RFP Title: Site Improvements at Peace & Plenty Park

Addendum #: 1

Site Improvements at Peace & Plenty Park

October 20, 2026

- NORTH ARROW
-
- SCALE
-
- DRAWING INFO
- DATE ISSUED: 10/19/26
PROJECT NO: PEAC.24.01
DRAWN BY: II, SG
CHECKED BY: MG
- SHEET TITLE
- Ex Conditions
/ Demo Plan
- L-2

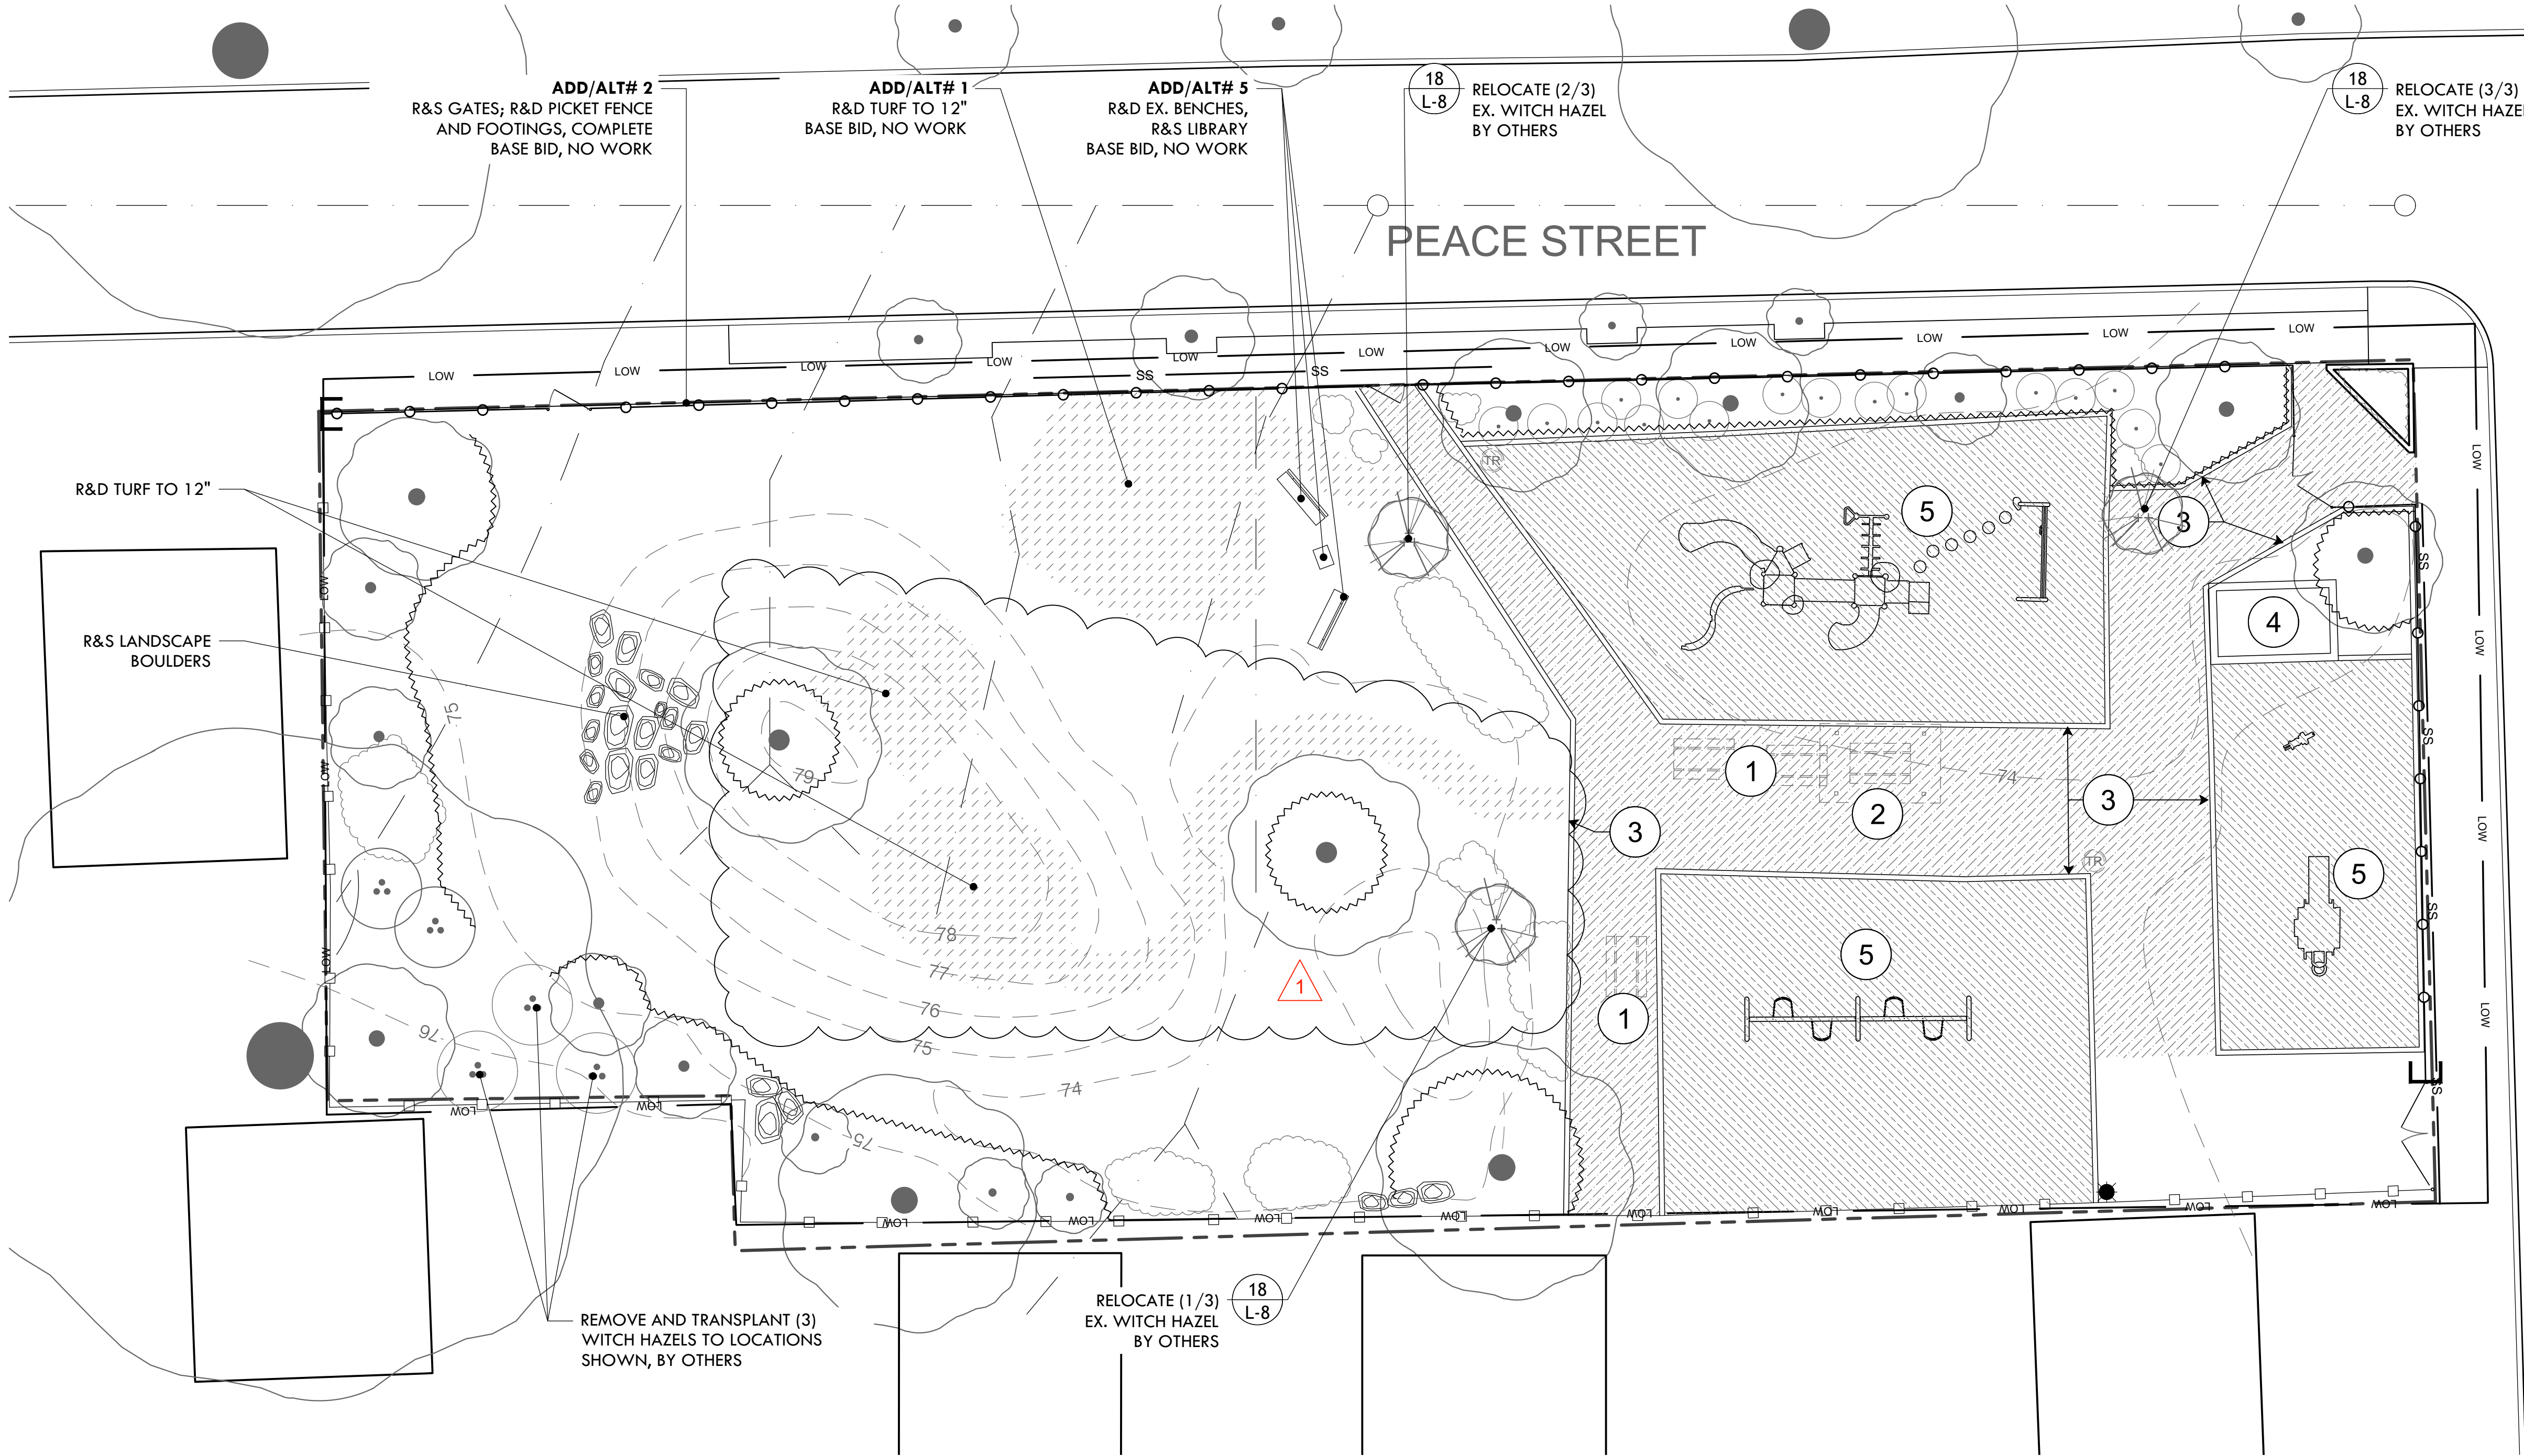
1. Addendum Cover Sheet (1 Page)
 - a. Addresses changes to the custom play sculpture and adjacent conditions
 - b. Includes removal of turf for the path leading up to the play sculpture
 - c. Other changes as noted
2. Construction Plans (5 Pages)
 - a. Sheet L-2 Existing Conditions/Demolition Plan
 - b. Sheet L-3 Grading Plan
 - c. Sheet L-4 Materials Plan
 - d. Sheet L-5 Layout Plan
 - e. Sheet L-9, Detail 32
